# Access Compliance Report

## Public Rights-of-Way

Intersection ID: 43934	Main Street: ALBEMARLE_RD	Cross Street: CIRCUMFERENTIAL_RD	Location: SE
ADA ID: F0962B9BCC0B	Ramp Type: Para	Initial Pass/Fail: Fail	Overall Compliance: No
Severity Score: 13.75			
Codes/Mitigation Info/Possible Solution		Field Measurements/Component Compliance

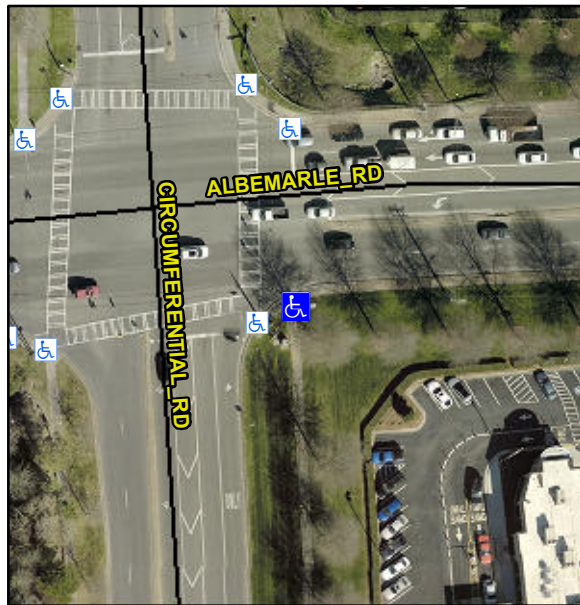
**RT RP < 5%**

**R304.3.2, R304.5.3**

Compliance	Description	Data	Compliance	Description	Data
N/A	Ramp Length LT (in)	60.0	N/A	Ramp Length RT (in)	79.5
Yes	Ramp Width LT (in)	60.0	Yes	Ramp Width RT (in)	60.0
No	Ramp Slope LT (%)	11.0	Yes	Ramp Slope RT (%)	1.8
No	Ramp XSlope LT (%)	3.9	No	Ramp XSlope RT (%)	2.4
N/A	Landing Length (in)	N/A	N/A	DWS Provided?	N/A
N/A	Landing Width (in)	N/A	N/A	DWS Contrast?	N/A
N/A	Landing Slope (%)	N/A	N/A	DWS Length (in)	N/A
N/A	Landing X Slope (%)	N/A	N/A	DWS Full Width?	N/A
N/A	Landing Curb? (Y/N)	N/A	N/A	DWS Offset (in)	N/A
N/A	Shared Landing?	N/A			
N/A	Gutter Ponding?	N/A	N/A	Gutter Slope (%)	N/A
N/A	Gutter Lip Ht (in)	N/A	N/A	Gutter X Slope (%)	N/A
N/A	Painted X Walk1?	No	N/A	Painted X Walk2?	N/A
	X Walk 1 Direction	To N		X Walk 2 Direction	N/A
N/A	X Walk 1 Width (in)	N/A	N/A	X Walk 2 Width (in)	N/A
	X Walk 1 Slope (%)	4.3		X Walk 2 Slope (%)	N/A
	X Walk 1 X Slope (%)	1.4		X Walk 2 X Slope (%)	N/A
N/A	Ramp inside XWalk1?	N/A	N/A	Ramp inside XWalk2?	N/A

**Remove & Replace Entire Ramp.**
